**CITY OF NEWTON, MASSACHUSETTS
PURCHASING DEPARTMENT
purchasing@newtonma.gov
Fax (617) 796-1227**

**ADDENDUM #2
INVITATION FOR BID #25-29**

ALBEMARLE PLAYGROUND IMPROVEMENTS PHASE I
--

Sheet Number:
L705

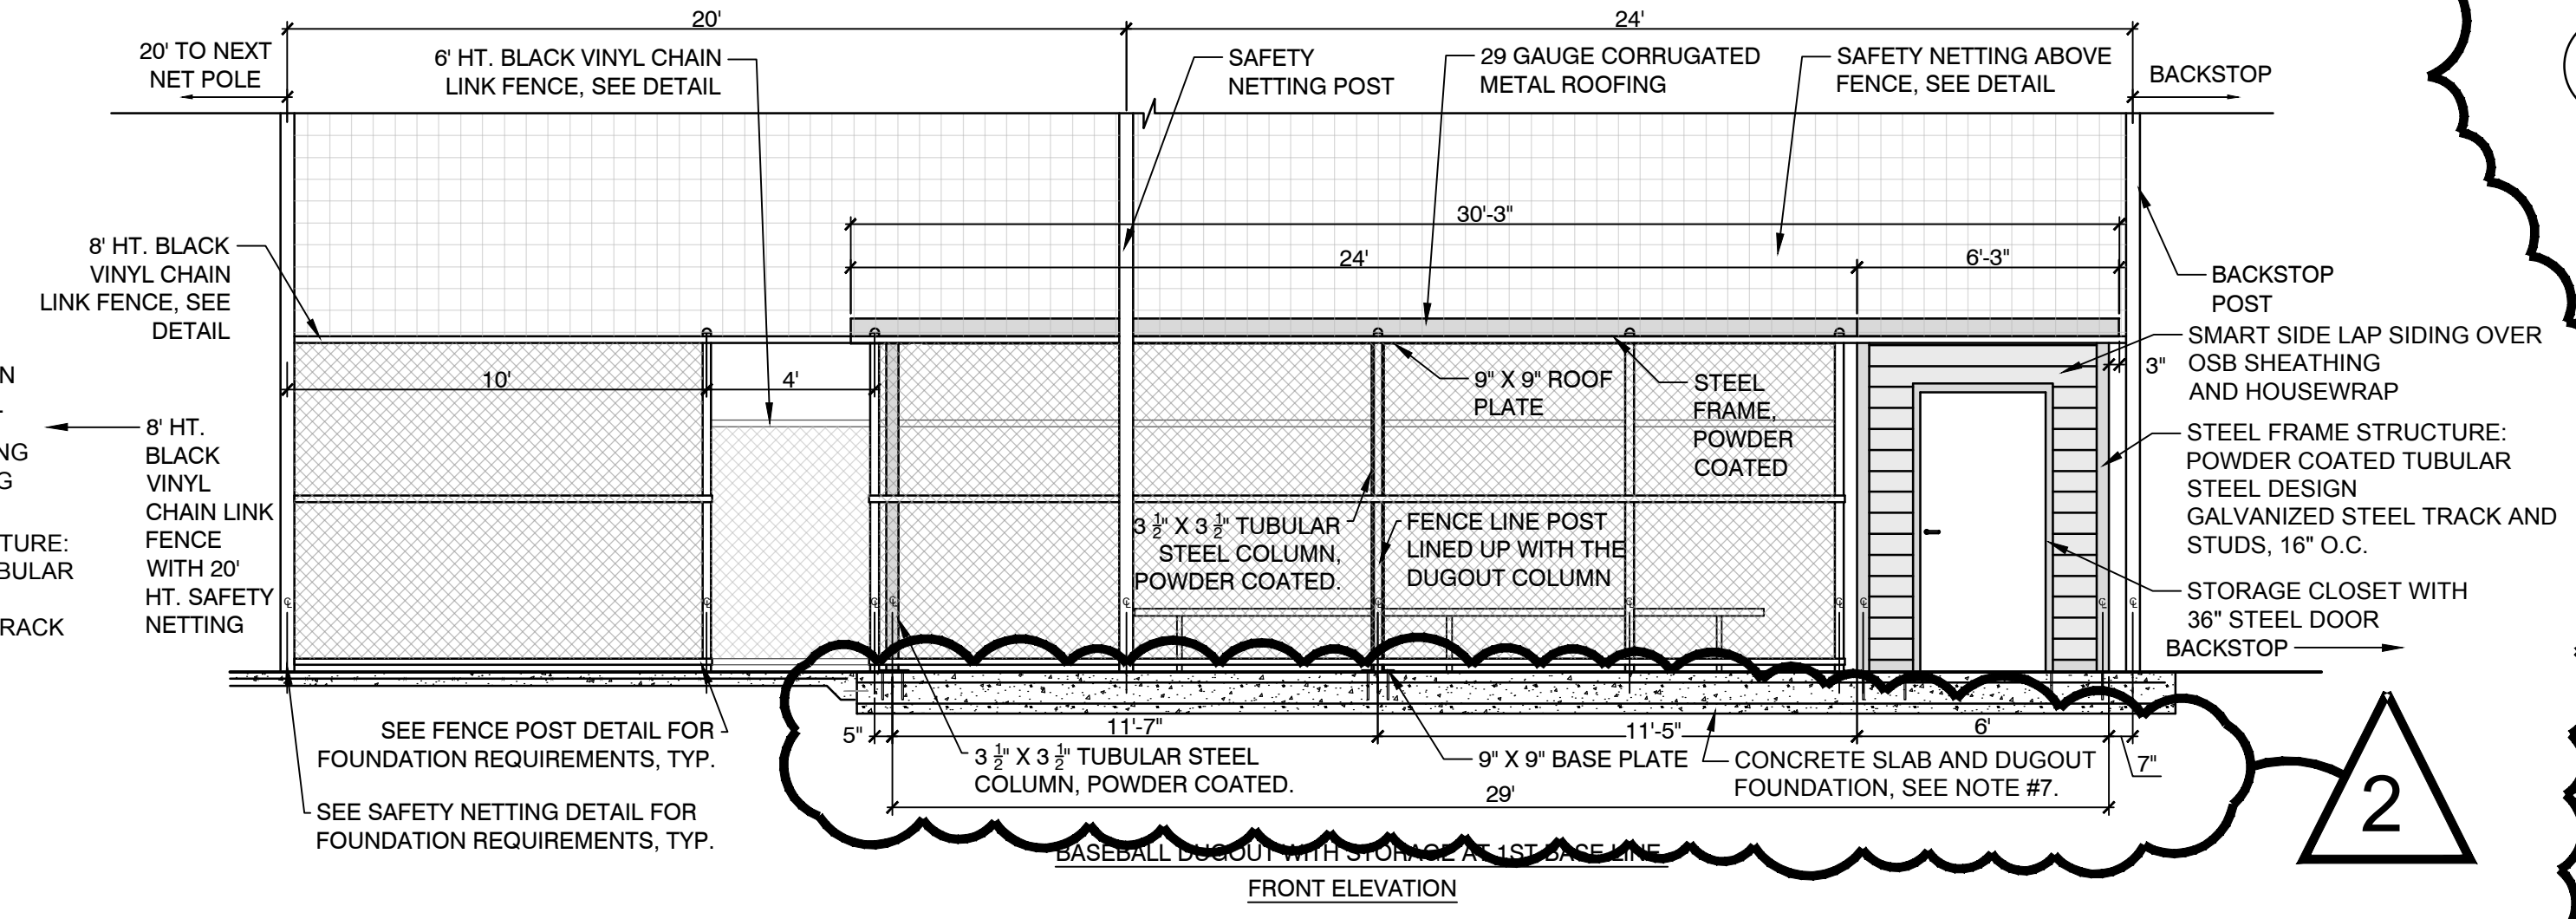
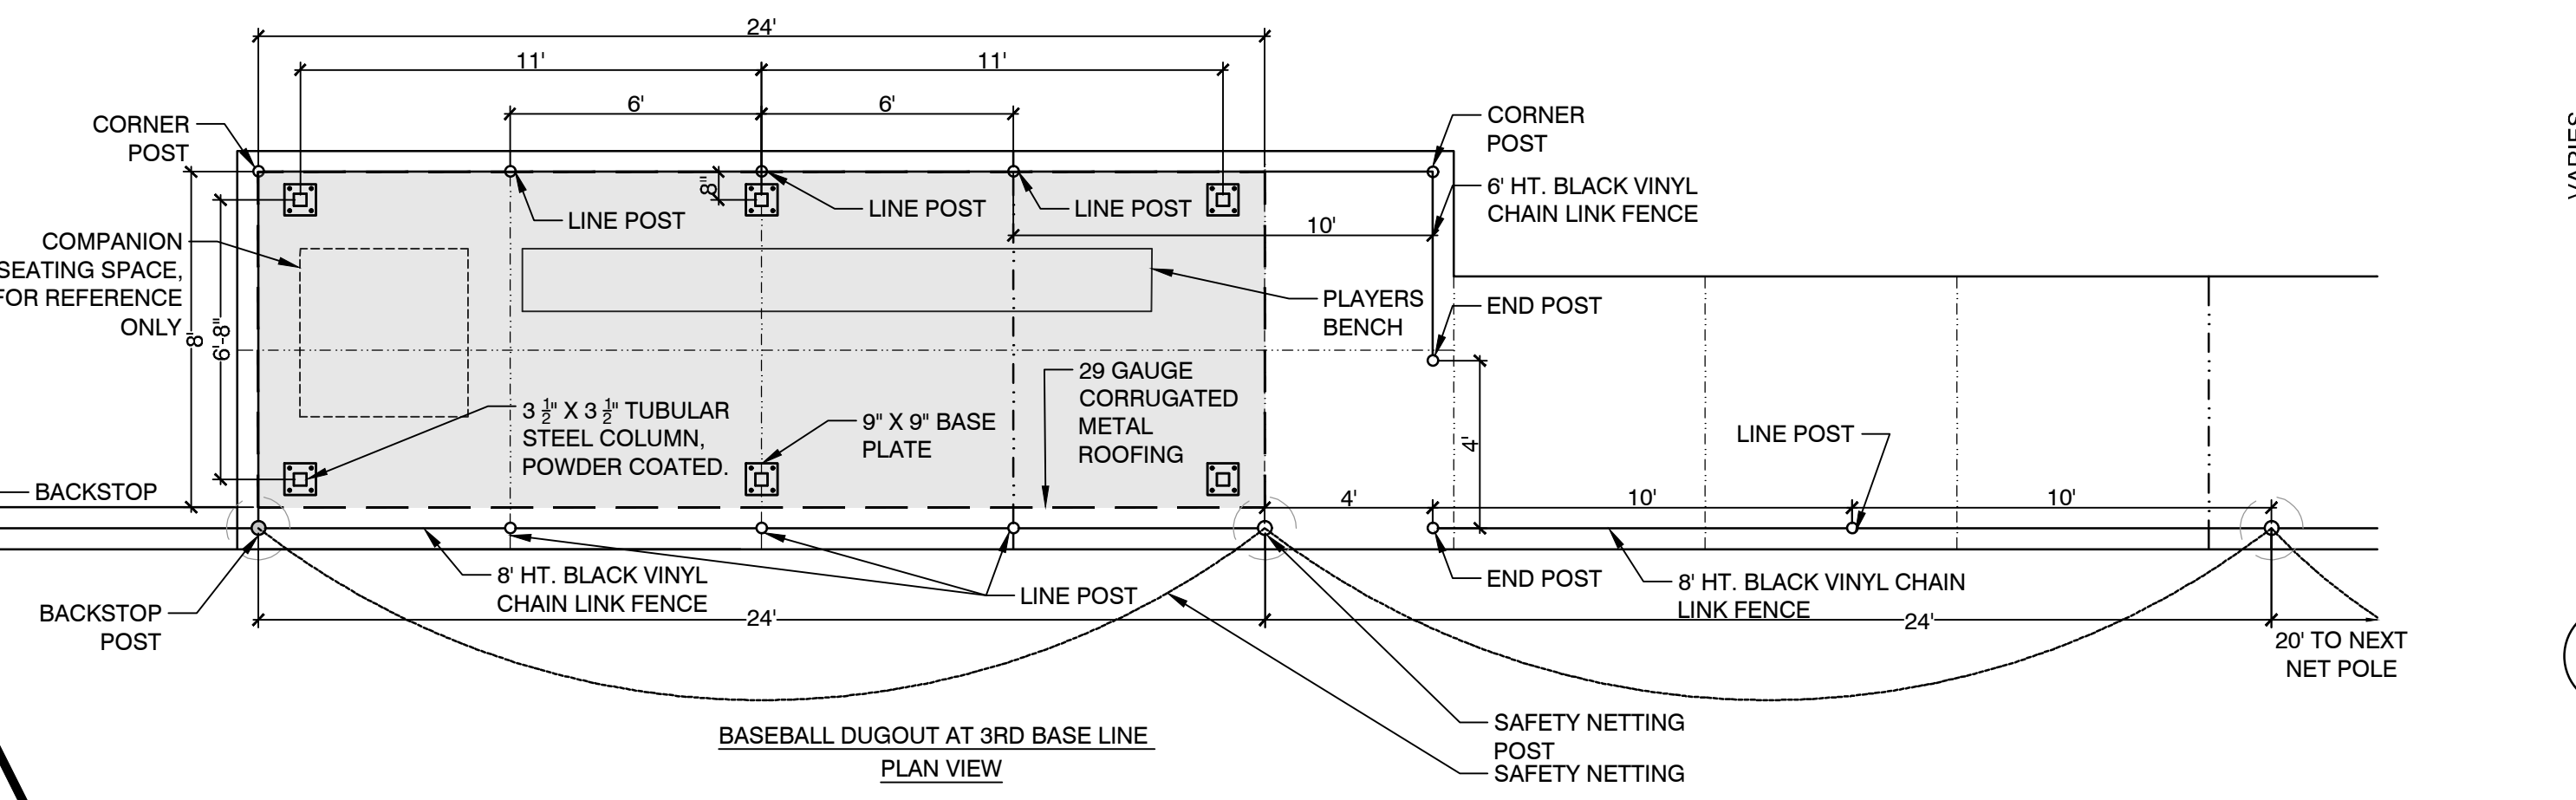
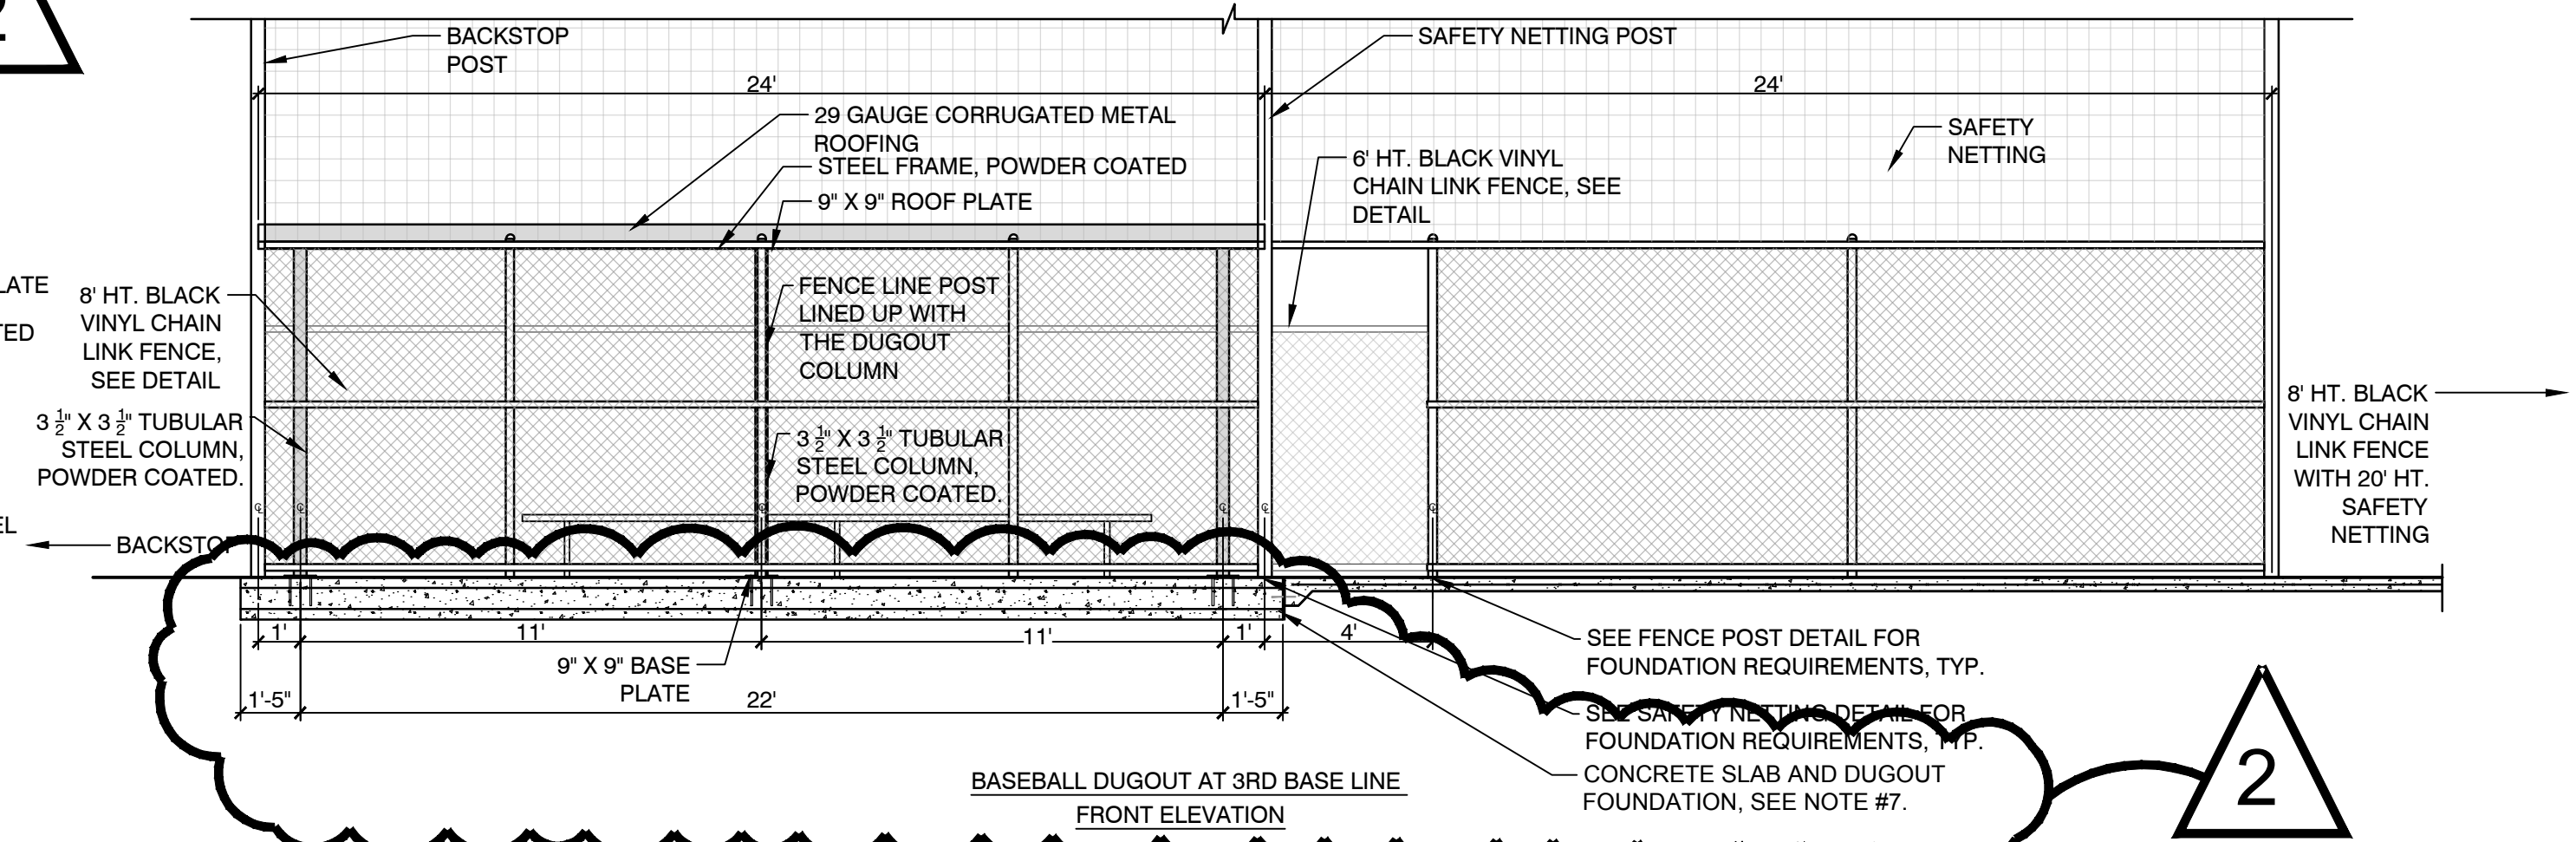
Q30. Please confirm which detail we should use for the dugout slab. Are we to follow details on L705 detail 1 & 4 or detail 10 on L701

A30. The concrete slab for the dugout foundation shall be designed by the manufacturer as shown in detail 10 on sheet L701 and as specified. See the revised sheet L705 in the attachments in this addendum.
